**City of Willamina
Planning Commission
Meeting and Public Hearing**

CITY OF WILLAMINA PLANNING COMMISSION
REVISED STAFF REPORT

FILE NUMBER(s): Subdivision #SUB 23-01 **“Ridgeview Heights, Phases 3-7”**
Variances #VAR 23-01, VAR 23-02, VAR 23-03, and VAR 23-04

B. PROPOSED REVISED SUBDIVISION PLAN (See full size plan in Exhibit B)

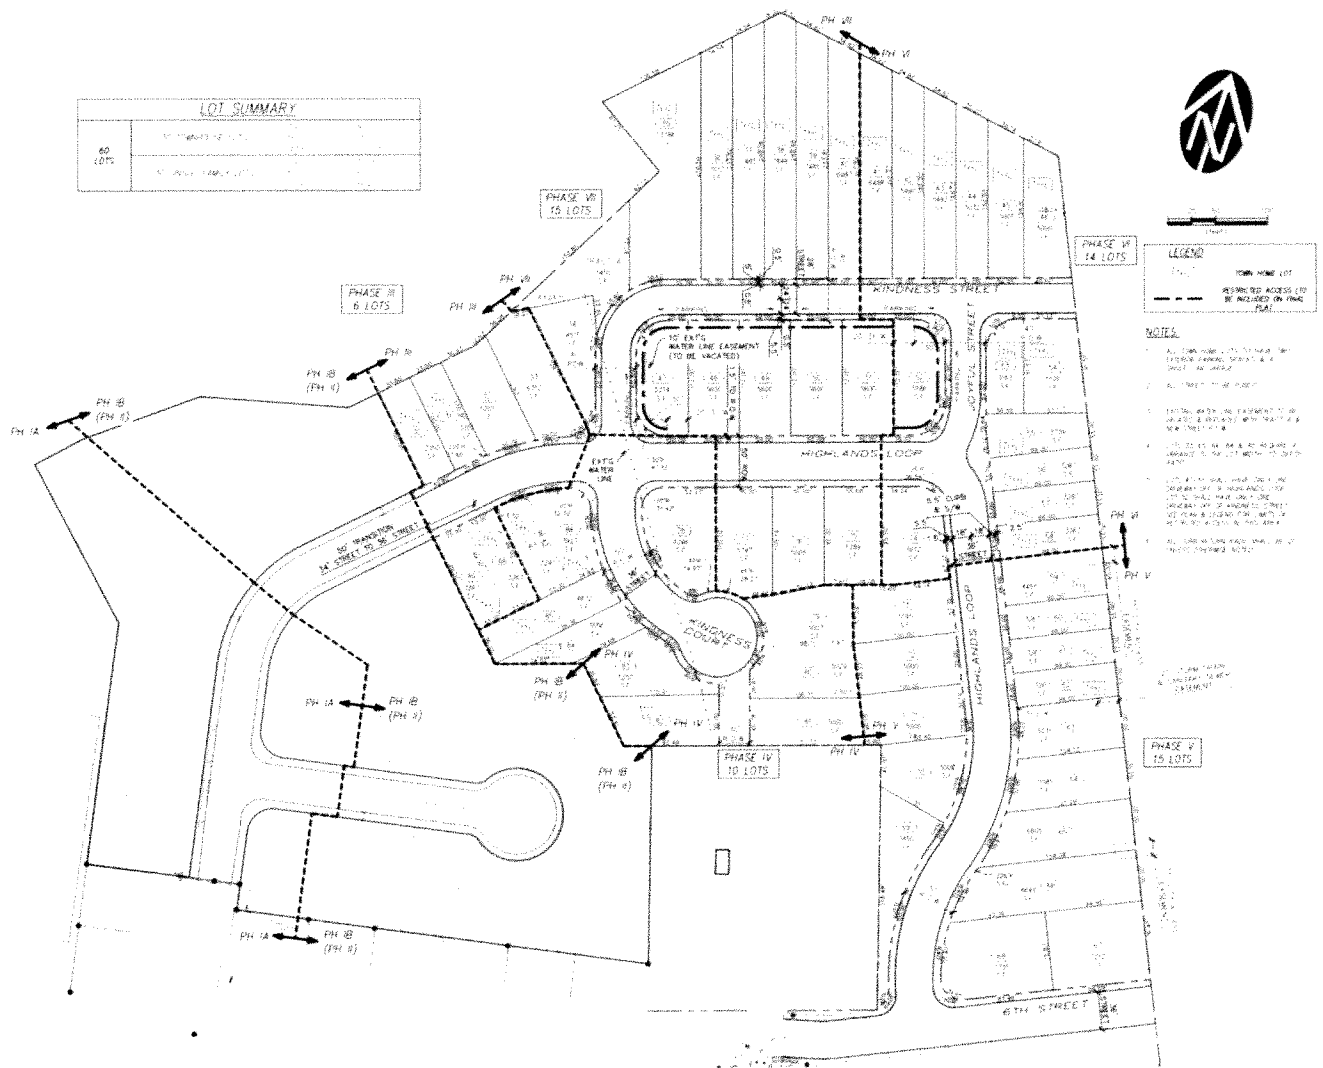
After the October Planning Commission meeting, the project engineer made the following plan revisions:

1. Revised Lots 36-46 to THL (townhouse lot), to meet minimum lot frontage widths.
2. Revised Lot 34/Tract A as requested by the City, to accommodate the new public raw water line.
3. Added restricted access to through lots 47-52 as requested by the City; allowing access from one street only. Lots 47 – 51 access from Highlands Loop, and Lot 52 access is from Kindness Street, to allow for street parking on Kindness.
4. Added Note 6 about the curb returns as requested by the City, in response to Fire Code radius.
5. Revised Lot 82 to show 50' of frontage.
6. Revised Phase III into two phases which now brings the total to seven phases.

A. VARIANCE #VAR 23-01: Variance to lot depth-to-width ratio for lots 33, 35-46, 65, 66, 84, 85.

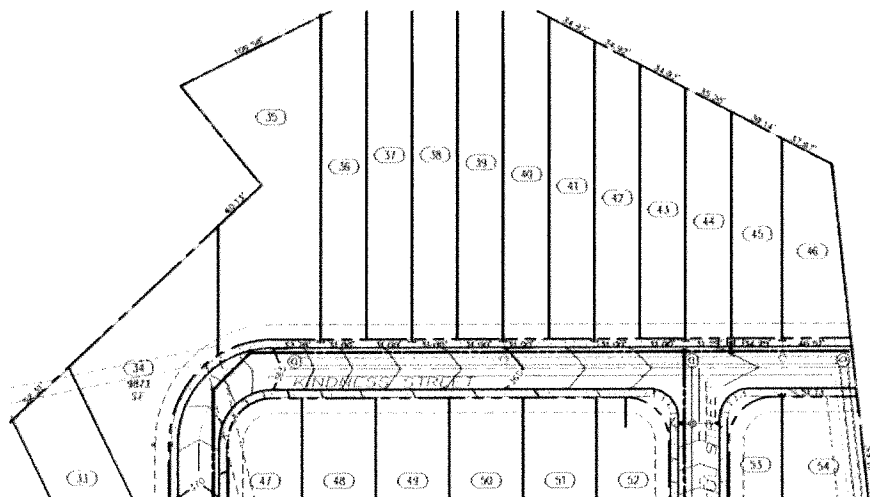
The applicant states “The variance requested is due to the existing property configuration and topographic constraints of the site. The northerly portion of the property is very steep eliminating the possibility of a street which would negate the need for a variance for lots 35 through 46. Because of the existing topography, it is necessary to have long, skinny lots (Lots 35-46). The configuration of Lots 33, 65, 66, 84 and 85 are restricted due to the existing property boundaries and the required street layout required to connect to the existing street network and provide ADA accessible routes. The lot width to depth ratio for these lots is not significantly over the Standard.”

Staff concurs with the applicant’s response. The variance is necessitated by the interest of utilizing the land most efficiently, while navigating steep slopes and street alignment challenges. The unique steep slopes render the northern portion of the lots unbuildable. For this reason, the applicant is looking for relief from the standard in order to build compact dwellings on narrow lots abutting Kindness Street. While originally envisioned as cottages, these narrow lots are now proposed to be townhouse lots (THL). The overall lot size for each of these lots exceeds the minimum lot size of the R2 zone. Related to the narrow lot size, staff has included a recommended condition of approval for the applicant to comply with the minimum lot frontage by either developing some of the lots as townhouses and/or reducing the number of lots on the block to meet that standard. Even when one or both of those actions are taken, this variance request will still be necessary, and would still be supported due to the constraints of the slopes. Example of the topography shown below in a screenshot from the applicant’s plan set:
